**CITY OF TEMPE
DEVELOPMENT REVIEW COMMISSION**

**Meeting Date: 10/14/2014
Agenda Item: 4**

ACTION: Request for a Development Plan Review for MERIDIAN AT 101, located at 2148 East Apache Boulevard. The applicant is Daniel Terlecki, Bethel Development.

DPR140182 Development Plan Review including site plan, building elevations, and landscape plan

SITE PLAN

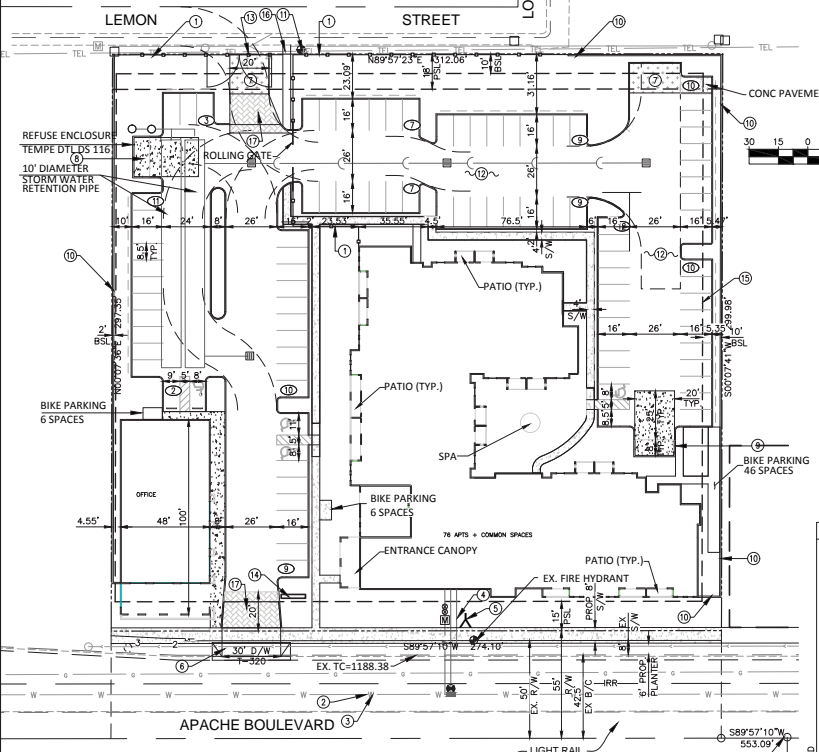
The proposed site plan is very similar to the previously approved design for Apache Villas. The proposed project does not provide covered parking, as Apache Villas did. The site has one driveway on Apache, reducing the pedestrian/vehicle conflicts from the existing three lots. The building layout provides public pedestrian access from Apache and from Lemon through the site to the commercial building and the residences, integrating the two buildings into the commercial and residential communities surrounding the site. Residents also have access to walk or bike north to the Multi-Generational Center. The circulation was challenged by requirements for fire and refuse access, the building and parking space locations are designed to accommodate on site turn-around for weekly refuse collection, and emergency vehicle access to all sides of the building. The parking area for residents is secured behind a gate while the public guest and customer parking, shared by the commercial tenant, is outside the gated area. A grass-crete product is provided along Lemon, to provide emergency egress if necessary, and at the north east corner, within the landscape buffer, to comply with circulation requirements for a fire truck to access the back and east side of the building. Pedestrian amenities along Apache Boulevard and on the west side of the apartments provide opportunities for residents to people watch and interact with the larger community. The taller

building is pushed to the east side, adjacent to two-story homes to the north, the smaller commercial building is pushed to the west side, very close to the Apache street front. The view from the north will be heavily screened with landscaping in the parking area and along Lemon Street. The site design balances the need for security and safety, without appearing as a walled compound or gated community, it is welcoming and open. The site is located within the transportation overlay district and has access to multiple modes of transportation. There are no requirements within the mixed-use zoning code that require a specific ratio of uses or the location of uses on the site. The interpretation of mixed-use has been applied on a site specific basis. The tax credit financing of this site required separation of the commercial use from the residential use; this model has been done on other sites, such as the Baer's den, a very similar scaled commercial project had a different architectural style to the rest of the student housing development. The separated commercial use meets the mixed-use intent, is appropriate in scale and design to the area, and conforms to the architectural characteristics of the larger building, using the same materials and colors. The scale of the commercial building is also similar to other established businesses along the Boulevard.

8. *Vehicular circulation is designed to minimize conflicts with pedestrian access and circulation, and with surrounding residential uses*; there is only one driveway entering the site, to minimize pedestrian conflicts. The parking is broken up by landscape medians and creates smaller pockets of paving in between the landscape. There is no vehicular access to the residential area to the north, with the exception of emergency vehicle egress over a grass-crete surface.

6. Provide 8'-0" wide public sidewalk along arterial roadways, or as required by Traffic Engineering Design Criteria and Standard Details.

7. Provide service yard and mechanical yard walls that are at least 8'-0" tall as measured from adjacent grade and are at least the height of the equipment being enclosed, whichever is greater. Verify height of equipment and mounting base to ensure that wall height is adequate to fully screen the equipment. Locate electrical service entrance sections inside the service yard, as indicated.

8. Provide gates of steel vertical picket, steel mesh, steel panel or similar construction. Where a gate has a screen function and is completely opaque, provide vision portals for visual surveillance. Provide gates of height that match that of the adjacent enclosure walls. Review gate hardware with Building Safety and Fire staff and design gate to resolve lock and emergency ingress/egress features that may be required.

9. Provide upgraded paving at each driveway consisting of unit paving. Extend this paving in the driveway from the right-of-way line to 20'-0" on site and from curb to curb at the drive edges. From sidewalk to right-of-way line, extend concrete paving to match sidewalk.

SOUTH ELEVATION
SCALE: 1/8"=1'-0"

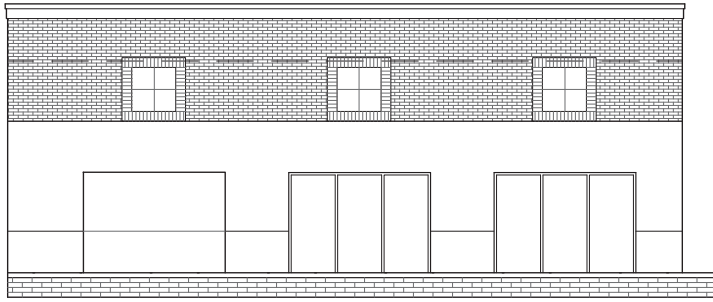
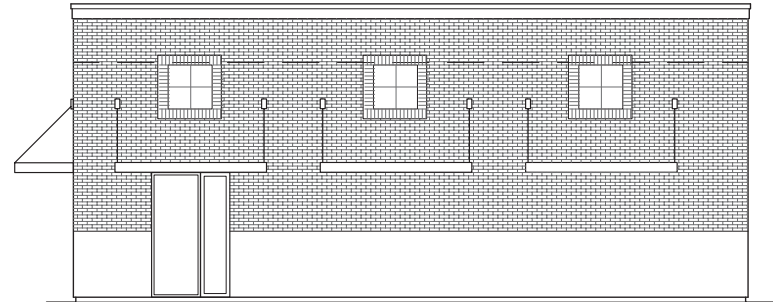
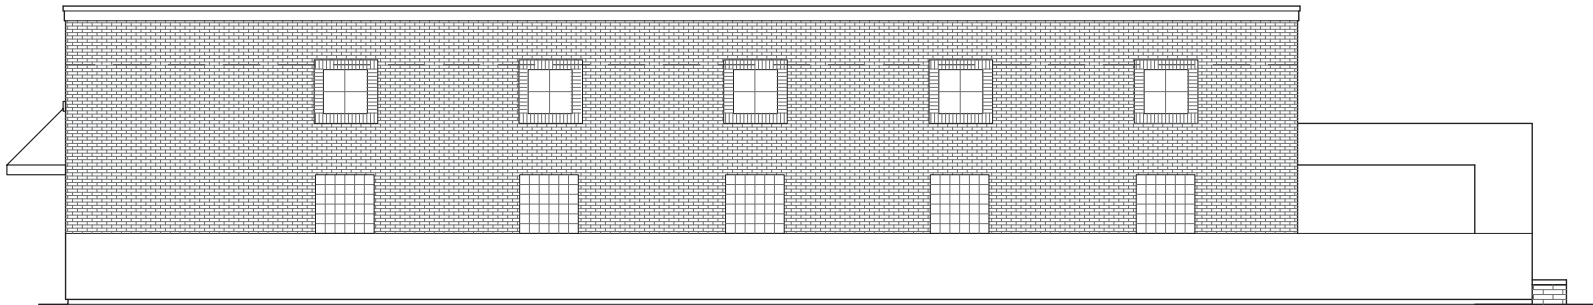
The four-story apartment community has a maximum height of 60 feet to the top of the roof elements. The former design used a conventional pitched roof design with asphalt shingles; the new design has a flat roof with parapets. The former design used predominantly stucco finish with faux stone at the wainscot; the new design is fifty percent brick veneer, with the remainder being a smooth stucco finish. The proposed material is superior in quality to the surrounding environment, and enhances the aesthetics of the area. The elevations demonstrate four-sided architecture, with a strong defined base of brick. This material provides a strong textural contrast to the smooth stucco. The vertical pop-outs and recesses provide more play with sunlight and shadows, articulating the design throughout the day. The overall effect of the changes updates the building to a more simplified contemporary look.

The second building is the commercial office/retail building located in the south west corner of the site. The primary entrance faces the south east corner, providing access to those visiting the site from Apache Boulevard (customers coming by light rail or bus), to residents living to the north or coming from Orbit from the Multi-generational Center, walking through the site, as well to as the residents of the development. There are windows facing north and south. The west side has glass block windows added for visual interest, natural light, energy efficiency and compliance with building safety requirements for building separation from the property line. The same colors and materials and building form are proposed for the commercial office/retail building. The proposed tenant of this building is the Tempe Community Action Agency. A condition of approval has been added to assure construction of this building, so that the pad site does not remain vacant. The scale of this building is in keeping with other single story small commercial uses along the Boulevard, providing a transition from existing older established uses and the taller new developments. The scale of the building enables residents to the north to maintain a clear site line to the south. The elevations are appropriate to the context of the area. Due to the timing of the staff receiving the elevations, a few specific conditions for the commercial office building have been added to address details that were not addressed in the presented plans.

13. The materials and colors are approved as presented:
 - Roof – flat with parapet
 - Primary building: Stucco painted ICI Tusk Tusk 30YY (light off white)

- Primary building: Stucco painted ICI Brushwood 20YY (medium taupe)
 - Fascia & Trim: Painted Metal ICI Deep Onyx 00NN (black)
 - Wainscot: Brick Veneer, Belden Brick 8601 (medium brick red)

- Glass Block: fire ratedProvide main colors and materials with a light reflectance value of 75 percent or less. Specific colors and materials exhibited on the materials sample board are approved by planning staff. Additions or modifications may be submitted for review during building plan check process.

14. The stucco wainscot on the commercial office building shall project a minimum of 2" from the face of the brick veneer above.
15. The painted stucco decorative squares on the commercial office building shall be recessed the depth of the brick veneer, and not be flush with the surface.

Preliminary Landscape Plan

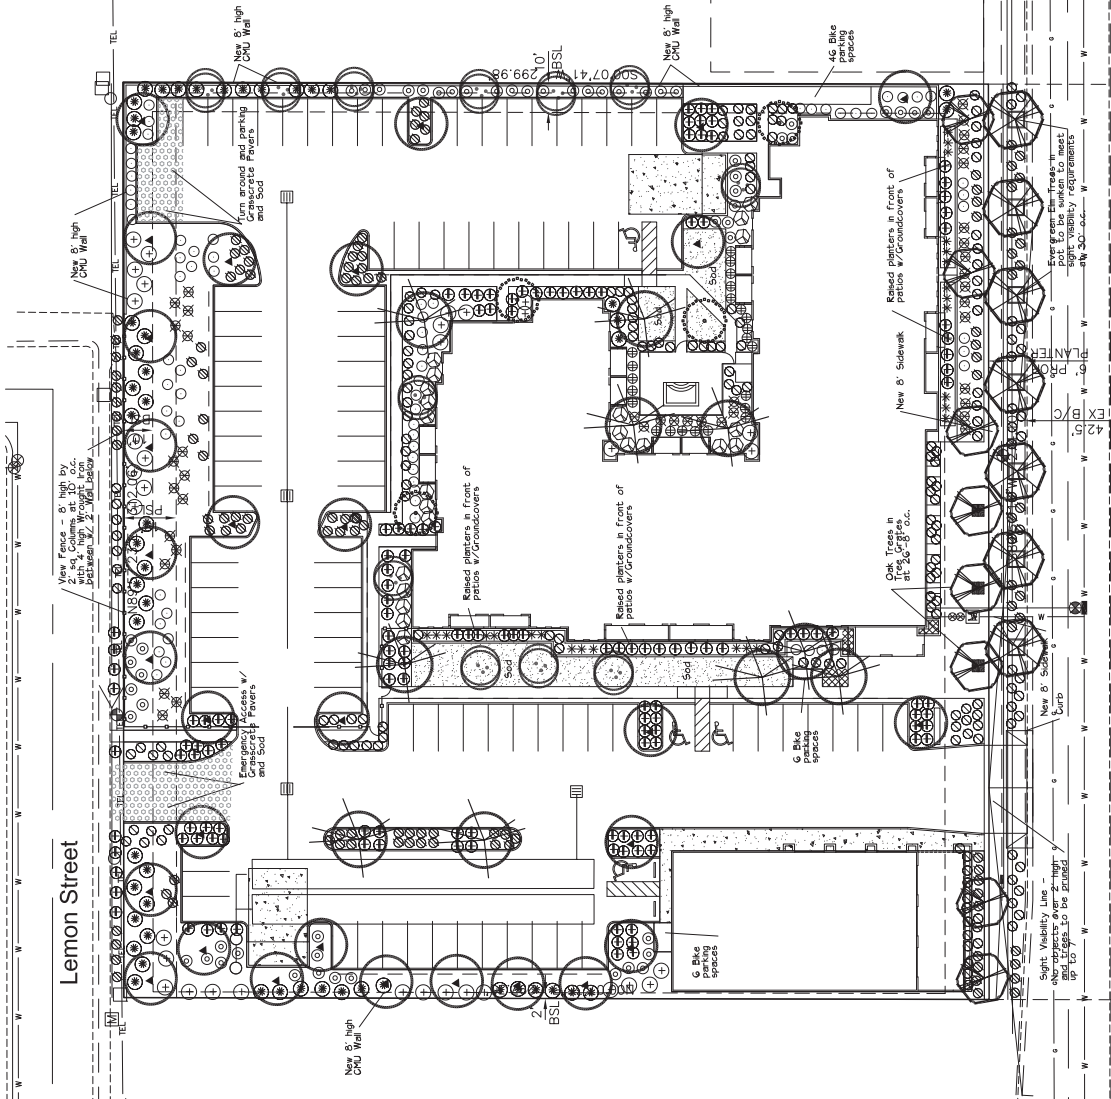
The landscape plan balances water conservation with a shady park-like oasis of plants that enhance the living environment for residents as well as for pedestrians and guests of the site. Trees include Acacia aneura, Mexican Bird of Paradise, Sissoo, Mesquite, Heritage Live Oak, and Evergreen Elm. This combination provides shade, seasonal color and bio-diversity on site. The shrubs include Valentine Bush, Sage, Ruellia, Tecoma Stans varieties. Accents include Red Yucca, and Twin Flower Agave. Groundcovers include Bush Morning Glory, Lantana, Rosemary, Ruellia and turf. Apache Boulevard is required to have street trees and a minimum of 33% shade. The challenge at this specific location is that sewer utilities run under the existing sidewalk, not in the street. There is a separation requirement from water utilities to any trees planted, which would require either an expensive relocation of the utilities, or relocation of the trees. Being on the north side of the street, shade trees would need to be planted on the south side of the sidewalk, in a landscape strip separated from the street. Due to the utility constraints, staff is working with the applicant to address the shade requirements of the Transportation Overlay District. Trees and landscape along the building front provides a buffer to residents in the first floor units, creating a more residential character. The sidewalk has been moved away from the street edge, and height appropriate plants are proposed over the utilities in this area. The parking lot is largely shaded by the shade canopies, and trees planted along the perimeter and within landscape islands. The parking lot is minimized by the use of a landscape median in the middle. Grass-crete is used in a portion of the frontage along Lemon to allow emergency vehicle access if necessary. The

overall landscape design is more heavily landscaped than most sites along Apache Boulevard, creating a comfortable pedestrian environment with shade, color, texture and seasonal change.

23. The plant palette is approved as proposed and specified on the landscape plan. Any additions or modifications may be submitted for review during building plan check process.

24. Irrigation notes:
 - a. Provide dedicated landscape water meter.
 - b. Provide pipe distribution system of buried rigid (polyvinylchloride), not flexible (polyethylene). Use of schedule 40 PVC mainline and class 315 PVC ½" feeder line is acceptable. Class 200 PVC feeder line may be used for sizes greater than ½". Provide details of water distribution system.

- c. Locate valve controller in a vandal resistant housing.
 - d. Hardwire power source to controller (a receptacle connection is not allowed).
 - e. Controller valve wire conduit may be exposed if the controller remains in the mechanical yard.

25. Include requirement to de-compact soil in planting areas on site and in public right of way and remove construction debris from planting areas prior to landscape installation.

26. Top dress planting areas with a rock or decomposed granite application. Provide rock or decomposed granite of 2" uniform thickness. Provide pre-emergence weed control application and do not underlay rock or decomposed granite application with plastic.
